May 29, 2013

Re: Exploration License
Wisconsin Statutes 295.44
Response to Comments

This office is in receipt of your May 24, 2013 letter which requested additional information for the Exploration License Application. The responses for each item are shown in italics:

GTAC EXPLORATION No. 1
TYPICAL SITE PLAN

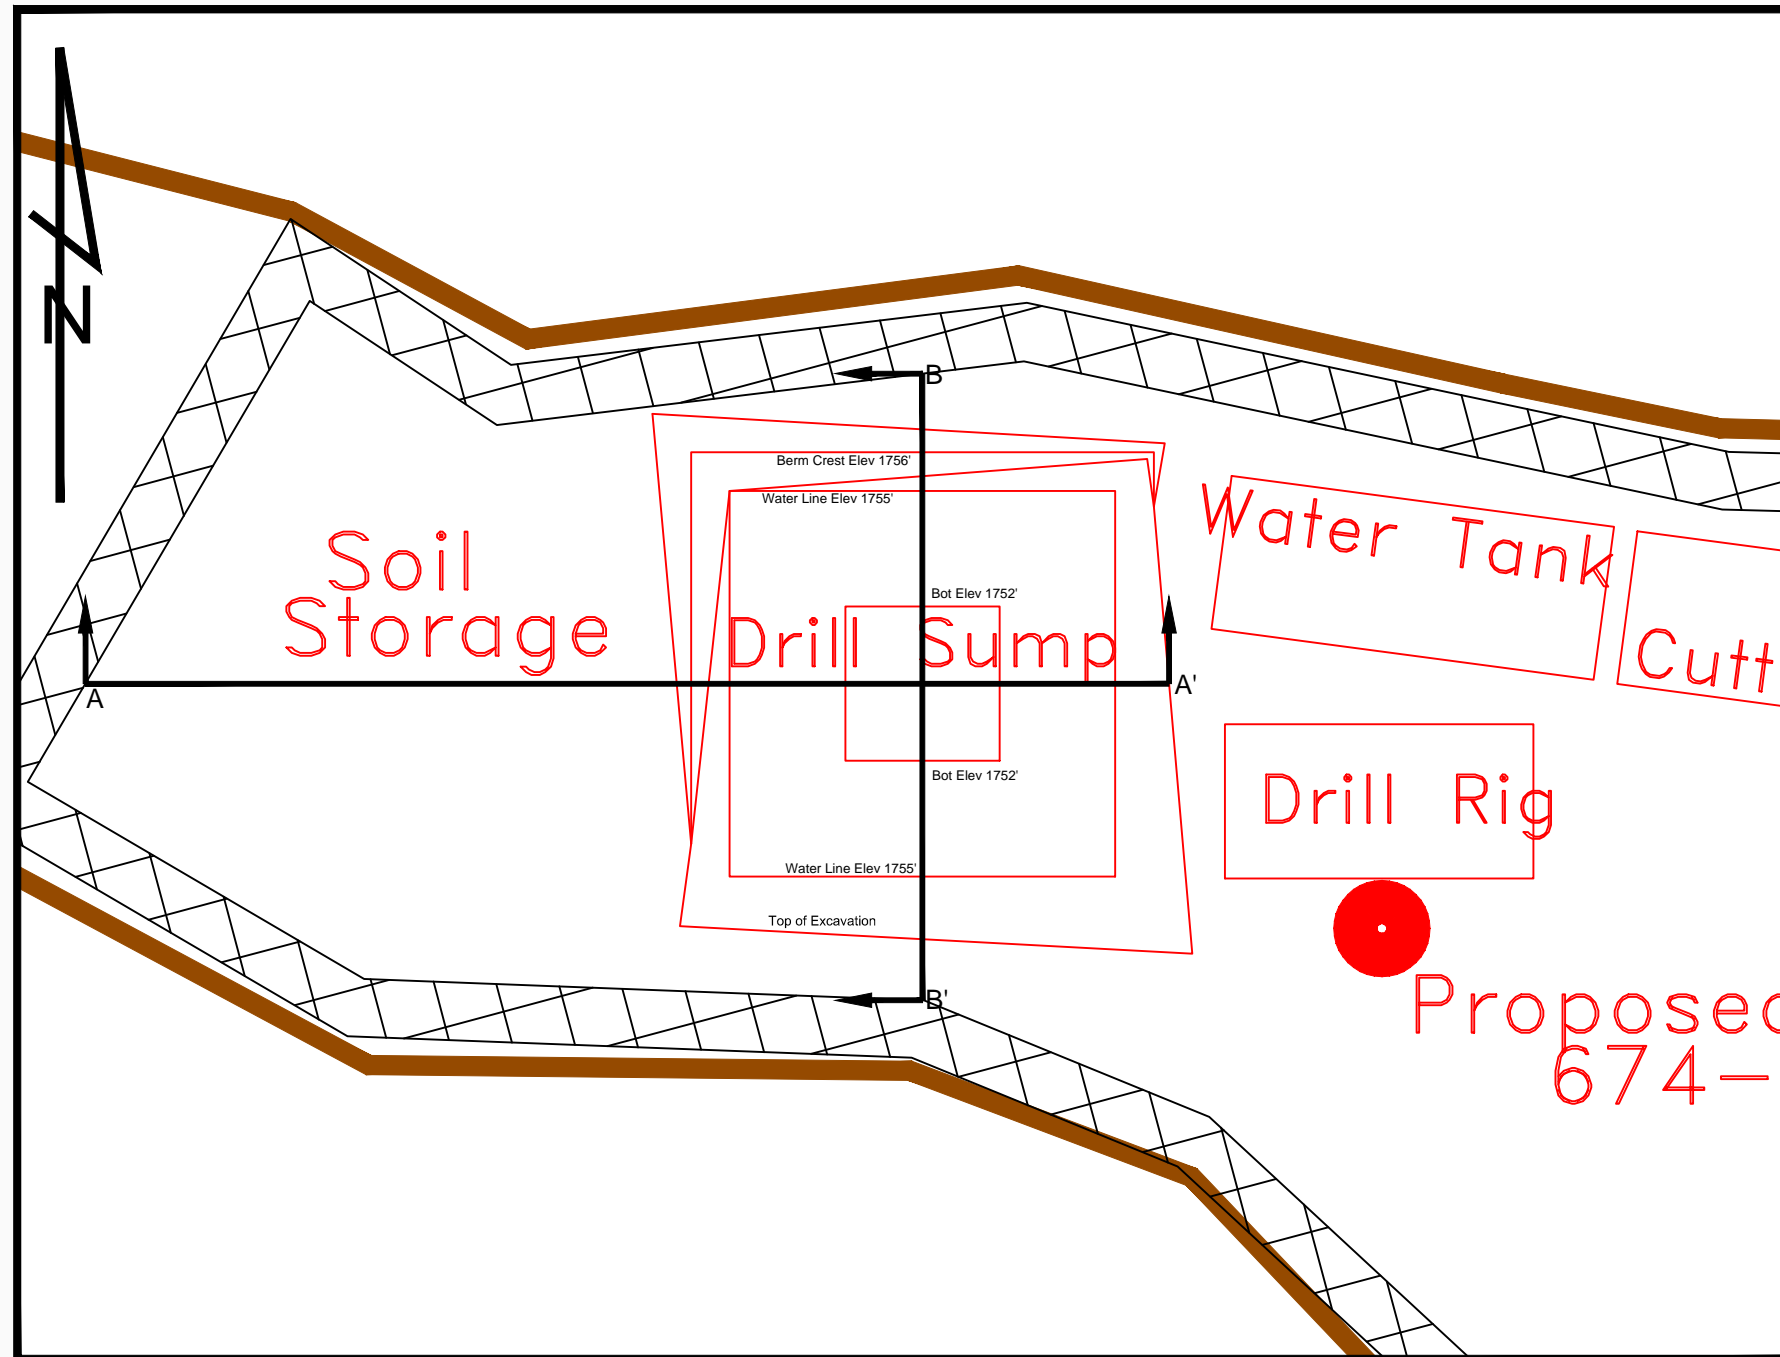
3. The application (p.4) indicates that drilling water could remain in the drilling site sumps for up to 30 days following drilling in order to allow dispersal of the water. Describe measures that will be taken to ensure the sumps do not overtop during this period if there are significant precipitation events during the time the sumps are open.

RESPONSE: The drilling contractor has indicated that the drill rig has a tank on board that is used to provide water to the drill during drilling activities. This drill rig tank will receive the overflow water from the cuttings tank for reuse. The dugout sump proposed in the earlier submittal would not be required.

Drilling water will be transported to the Collection Tank Central Location within the Cuttings Tank for dispersal. A revised Typical Site Plan is provided to illustrate the piping arrangement.

GTAC EXPLORATION NO. 1
COLLECTION TANK CENTRAL LOC.
PLAN VIEW

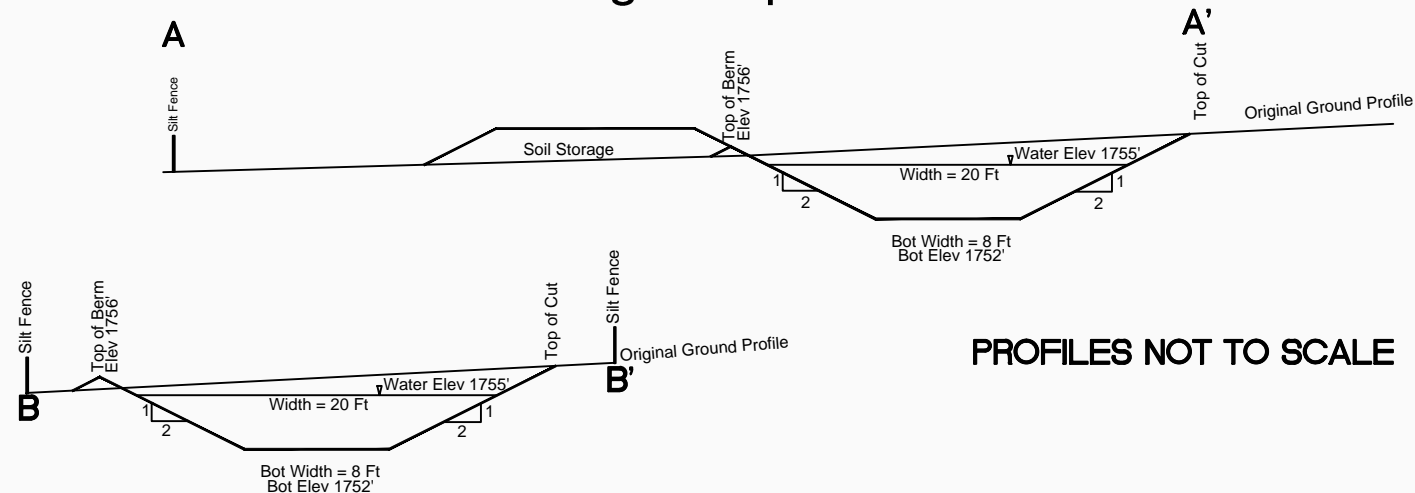
4. The application (p.4) proposes that the sump at the Collection Tank Central Location will have minimum dimensions of 40'x40'x4'. Please provide the estimated maximum dimensions of this sump. Also, specify how long water will be allowed to remain in the central sump before it is transported to a wastewater treatment facility.

RESPONSE: A dimensional sketch is provided to illustrate the dimensions of the sump and the general arrangement of the construction details. The sump size will be a minimum excavation of 20 feet wide by 20 feet long by 3 feet deep. The sump will be provided with a minimum of 12 inches of freeboard (measured from the top of the crest of the structure to the top of the water elevation). This will allow the collection of any precipitation without overtopping the sump.

The maximum size of the drilling sump will be no more than 40' X 40' X 4' deep. 20% greater than the proposed dimensions.

The sump will be allowed 30 calendar days from the date of the last drilling water to enter the sump to disperse the drilling water. If the drilling water does not disperse, the drilling water will be transported off the project to a municipal waste water treatment plant for disposal. The dispersal sump would then be backfilled and reclaimed.
